WBC Planning Application 260353 – OBJECTION (Rev 01)

Land north of Broadwater Lane and west of Hogmoor Lane, Hurst
Permission in Principle application for the proposed erection of a maximum of 7 and a minimum of 5 dwellings, including formation of an access from Broadwater Lane.

Submitted by: A A Butler

Date: 7 March 2026

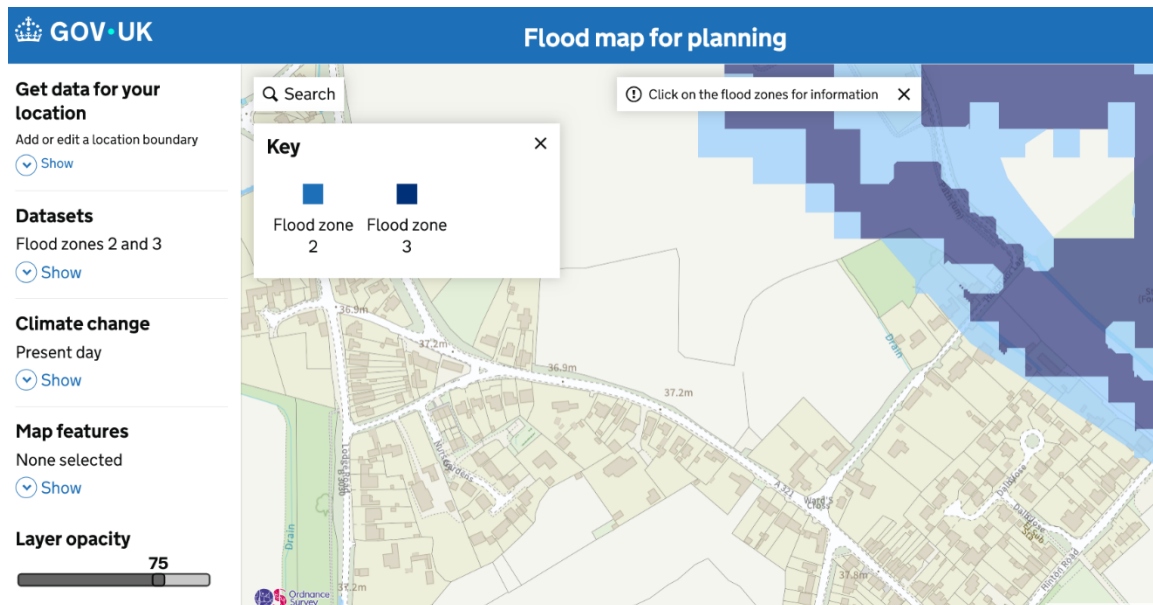
5HU030 site frontage, and above (right) Hogmoor Lane southeast of 5HU030 site - both flood zone 1 and where Application: 260353 surface waters will drain!

Above (left) A321 southwest of

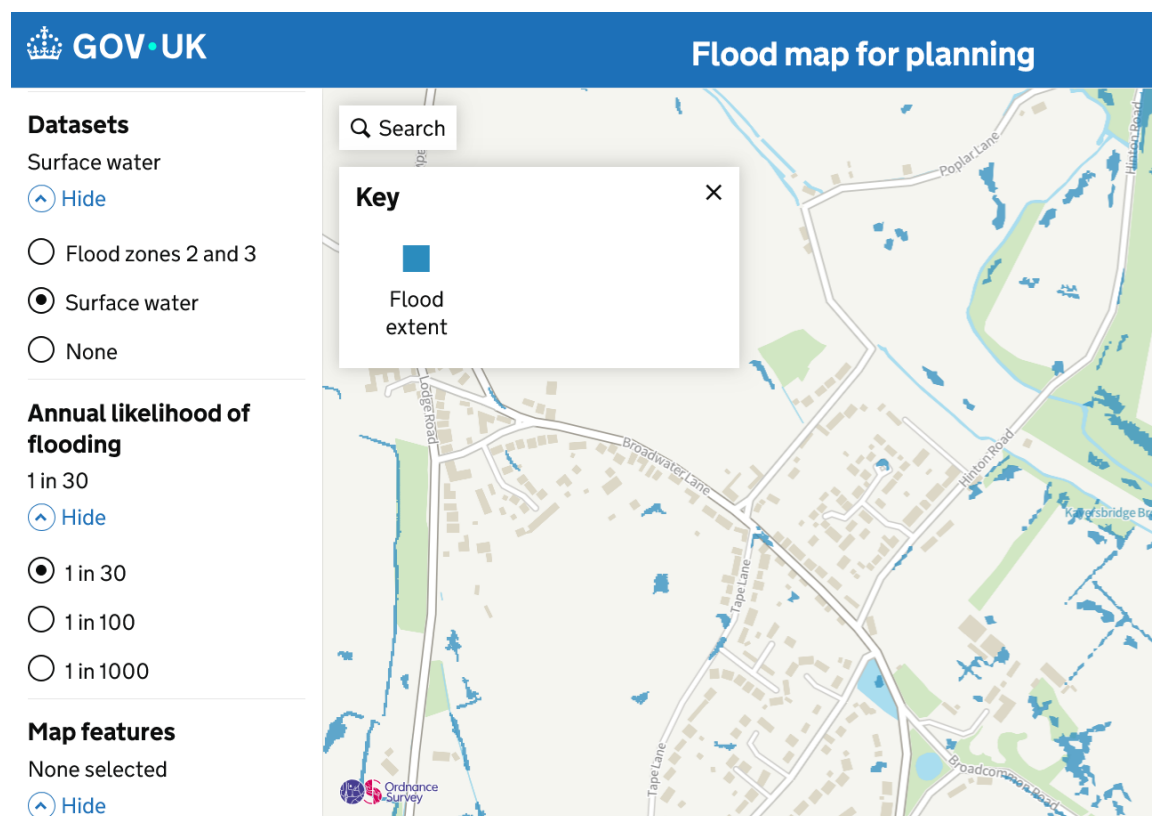
(4) Fluvial and Pluvial GOV.UK Flood map for planning maps rolled-out in March 2025 are flawed and should be used only with due care and scepticism: In the screenshot (below), the current GOV.UK “Rivers and sea” flood map for planning shows zone 1 with absolutely no flooding on most of 5HU030 site, also zone 1 (no flooding) in surrounding Broadwater Lane/A321 or in Hogmoor Lane, the zone 1 designation extending northeast beyond Apple Tree Cottage bordering the northeast site boundary drain (by the stranded vehicle photos (1)).

Similarly, the current “default” GOV.UK pluvial surface water flood map shows no flooding in the next 30 years next to the site in either Broadwater Lane or at all in Hogmoor/Poplar Lanes.

Figure 2.5: Level 1 SFRA Risk of Flooding from Reservoirs Map

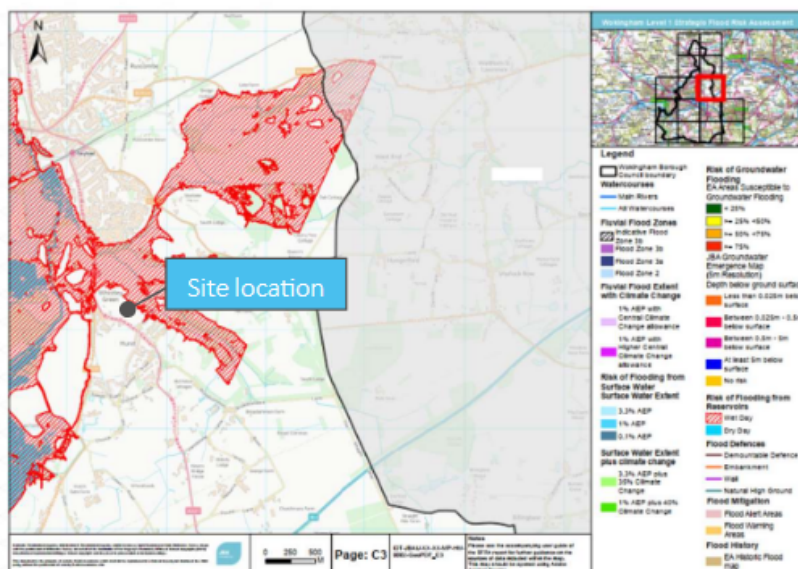
(14.3) Reservoir flood risk is an issue for Hurst: Clearly the Applicant originally attempted a deception to evade Hurst's reservoir flood risk. The supplementary note appears to now address this issue in 2.5.1 stating the site remains in an area that is not at risk of reservoir flooding, see screenshot (below) unhelpfully zoomed out hiding any detail.

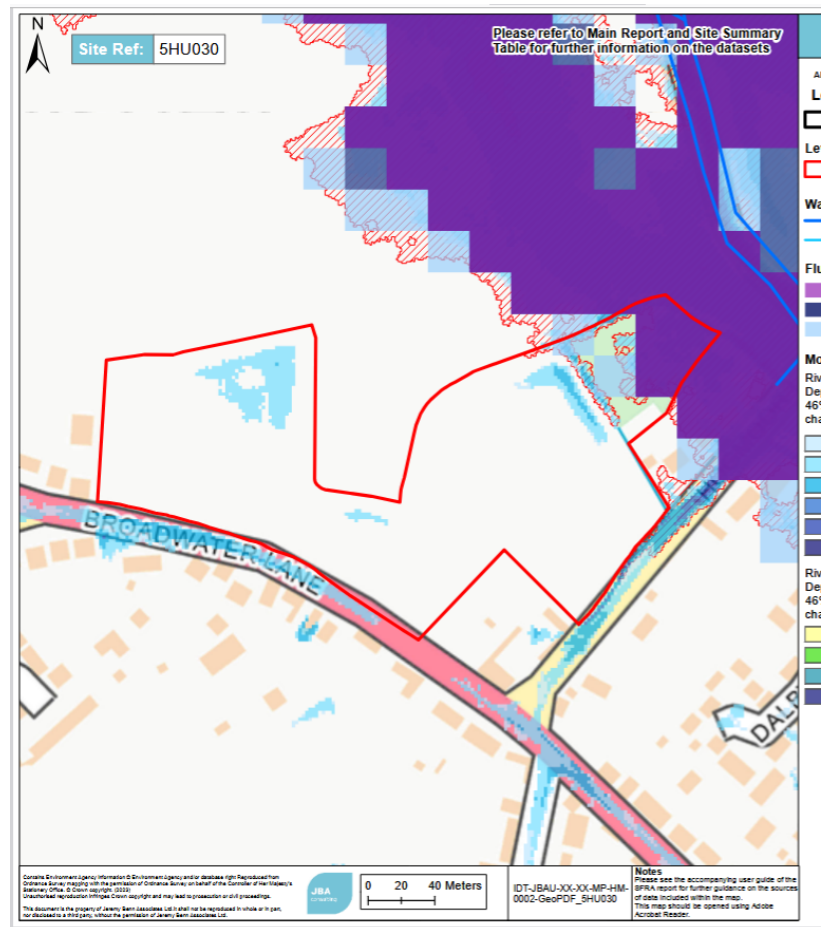
(Right) Ref: *Wokingham Council Evidence Studies – Climate change, flood risk and environmental sustainability – Level 2 SFRA 2023 Appendix D Site 5HU030 (PDF)*. Zooming-in on the (use-with-great-care) online flood risk information for the greater low-lying 5HU030 site, Broadwater Lane bordering the southwest boundary is subject to regular frequently photographed surface water flooding, as is Hogmoor Lane bordering the southeast boundary, which is also where sewer surcharging has been recorded close to the junction with A321.

Onsite, the computer prediction shows areas of standing water which again have been photographed with ponding standing surface water already visible this year 2026 in the proposed location of Application: 260353 **PLOT 1**. This computer tool does appear to show local surface water flood risk more accurately but not the full extent experienced.

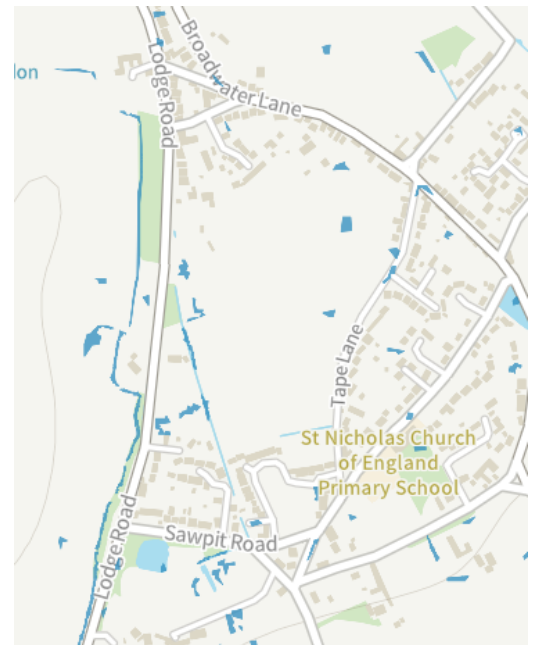
With respect to WBC Applications: 252934 & 242067, and if one looks carefully, this superseded map accurately shows the correct extent of flooding covering most of an adjacent neighbouring Nursery Close garden, see screenshot (right). This recent flooding extent is no longer predicted by the new GOV.UK roll-out flood maps for planning, fluvial or pluvial. Individual

“postcode” risk has also been reduced, typically “Med” to “Very low”.

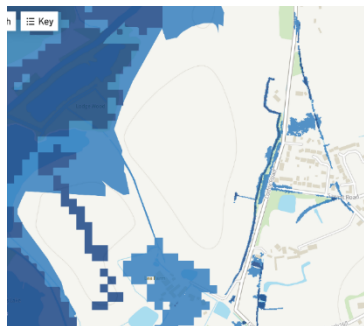
In the photo (right) the sheen of the previous day's rain can be seen still running off the capped landfill hill towards Hurst into the Hurst Landfill perimeter ditch north of "Old Lodge". This significant ditch and conduit

for zone 3 fluvial flood risk pictured is incorrectly not shown north of "Old Lodge" towards Whistley Green on the current GOV.UK map screenshot (left). Surely knowing of this error and its proximity to the Lodge Road sites, the onus should be on WBC Planning or as LLFA to advise any developer of the omission together with its additional flood risk and

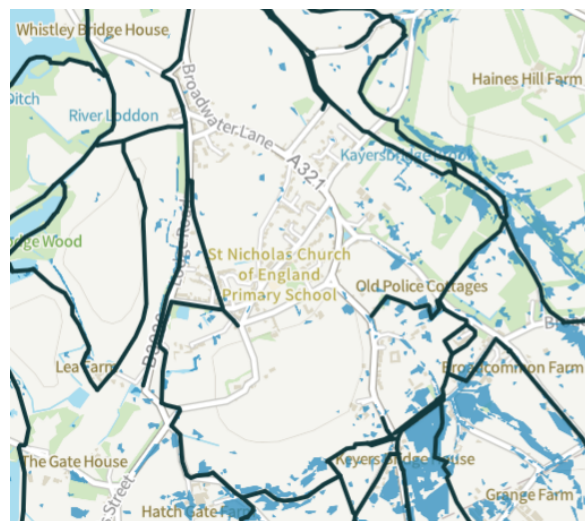
Also in the current GOV.UK/EA/OS Flood Map for Planning photoshot (above left) The same GOV.UK map absurdly shows the 44m AOD top of the southwest Hurst Landfill hill (a similar height to Hurst's Church Hill) with a strip of Flood Zone 3 risk above waste storage cells 01 and 02. A full 7m higher than current developers' proposed building sites in Hurst, perhaps seemingly far apart but on the same low 37m AOD level such as Applications: 260353 (Hogmoor) and 252934 (Lodge Road). With two such very obvious flood mapping errors within only a small area of Hurst should not WBC as LLFA be advising this online data for Hurst should carry a suitable warning "[GOV.UK responses may include errors.](#)"

Note, comments above apply to detailed GOV.UK Flood map for Planning for "planning scoping". Less detailed map options for "buying and selling" and for "insurance" appear similar to superseded SWFR maps but with flood extents slightly reduced, and individual "postcode" flood risk assessment for individual properties was also unaccountably downgraded as of March 2025 with (for example) a previous "Medium" risk assessment now arbitrarily changed to GOV.UK "Low Risk" classification – despite climate change considerations and the actual risk remaining unchanged.

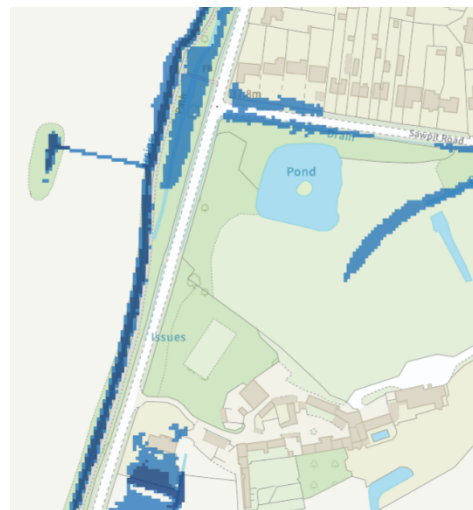
Annotated just below "Black Bridge", the important "Weir" (screenshot left) in the east (Hurst) bank of the Loddon is shown (but not annotated on GOV.UK flood maps see screenshot right). This preferentially dumps higher River Loddon levels towards Hurst into the Flood Zone 3b water storage area of Sandford Lane/Lavell's Lake, a preferential flood water storage area indicated by the OS wading bird "Nature reserve" (not "cross-hatched" EA

"stored water"). Details of this old weir, which is located just west of the Woodley/Hurst boundary by a few metres, were not included in WBC SFRA 2020 Table 12 list of structures.

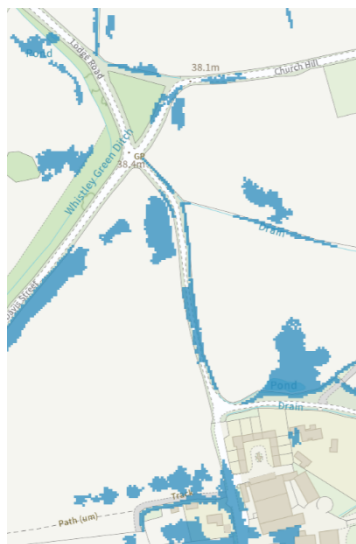
GOV.UK data utilizes OS data and the screenshot towards the south of Lodge Road (right) is currently annotated “Issues” on the GOV.UK Flood Maps (see later detail). What these issues are is not known but are likely to include the following:

- No ditches draining south or north either side of Lodge Road.
- To the west, very close proximity to the adjacent Waste Landfill perimeter ditch shown as GOV.UK Zone Flood Zone (3) and (2) risk with the added pollution risk of leachate and dissolved gas contamination.
- Close to Landfill gas vents/ sampling points.
- No active culverts under Lodge Road although damaged remains of headwalls can be found.

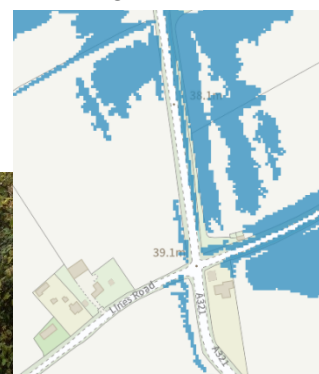
All surface water drainage from the Martineau, Sawpit and Lodge Road area and Willowmead Fields will have to pass across this area before draining anticlockwise around Church Hill towards Keyers Bridge. From the soggy area south of Church Hill neither the GOV.UK Flood Maps or Ordnance Survey Maps show active ditches draining towards Keyers Bridge correctly or at all. For instance, all that is left of the active flowing Hatchgate Ditch to the west side of Lines Road is pictured in the photo

(right) with a strong flow south directly towards Hatch Gate Farm, as indicated by the stick and ribbon in the foreground. Lots of maps wrongly indicate this flow north. February and March are perhaps a good time for WBC as LLFA to survey what is happening in these ditches. There are simply no ditches shown along Lines Road on the 6 ¼” OS Map. In the GOV.UK Flood Map screenshot (left) the active ditch pictured is not shown at all but the stagnant “swale” ditch on the opposite side of Lines Road is shown.

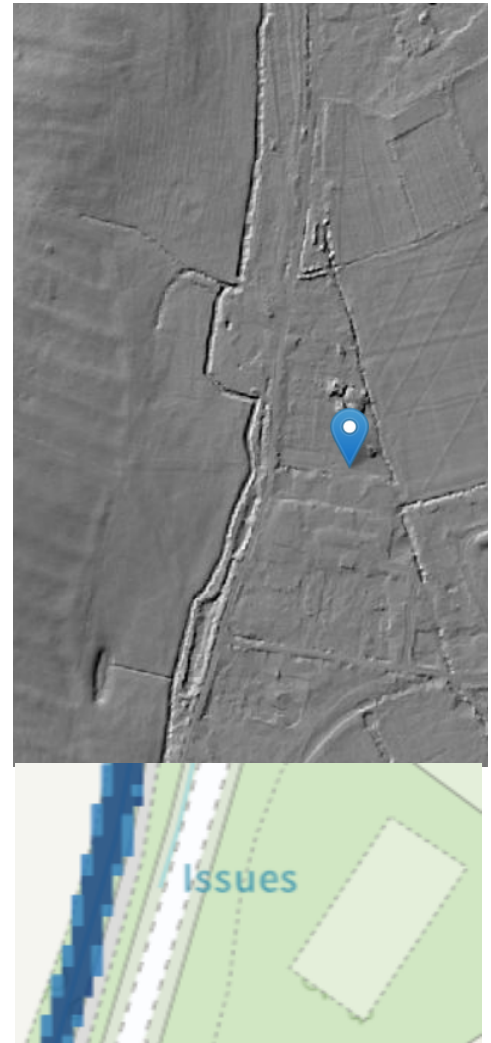
Degraded and trapped Hatchgate Ditch tributaries bordering Lodge Road Application: 242067 site and Martineau development can be seen to the right of the LiDAR screenshot; these ditches drain nowhere with their extent incorrectly shown on OS mapping.

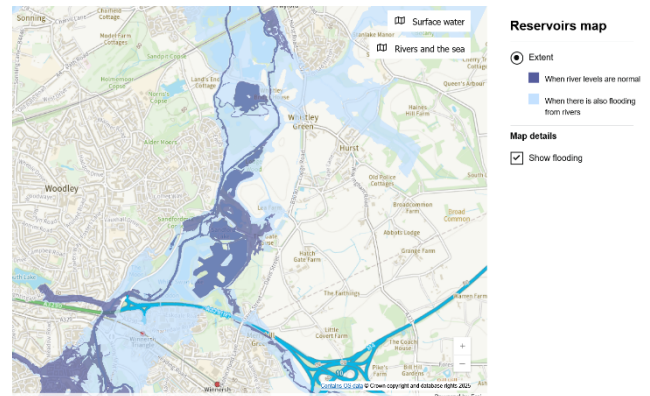
Further south in the GOV.UK Flood map for planning screenshot (lower right) and subject to Flood Zones 2, and 3, leachate and dissolved gas contamination, the Summerleaze Hurst Landfill perimeter ditch can be seen just to the west of Lodge Road. All natural surface water drainage for central Hurst east of Hurst Landfill ditch is now south across the surface area annotated “Issues” and then east anticlockwise around Church Hill as already described. This includes drainage from Lodge Road, Martineau, the Sawpit area, the new development Little Acre and in due course Application: 253074 Willowmead Fields drainage. Ultimately surface water this Lodge Road area will flow and seep towards Hogmoor Lane.

Why is this significant ditch feature forming a conduit for fluvial flooding not shown on OS mapping?

Are WBC Planning able to help expedite Ordnance Survey to get this crucial core document and associated online data reviewed, improved and updated for Hurst?

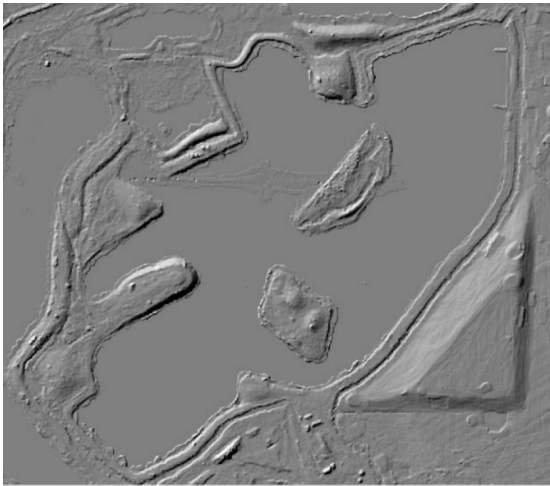
The stop-log weir to the northeast of Black Swan lake is shown on GOV.UK Flood Maps for Planning and on Ordnance Survey master maps as “Sluice”. This weir or **dam** (as referred to in WBC core data) is not shown or annotated on normal OS Maps. There is no indication on GOV.UK or OS maps of the raised level and embanked nature of Black Swan Lake or that it is stored water that could be released.

The photos of the weir show that it comprises removeable stop-logs, held in steel slots in concrete pillars with steel sheet piling running into the surrounding earth/gravel embankment.
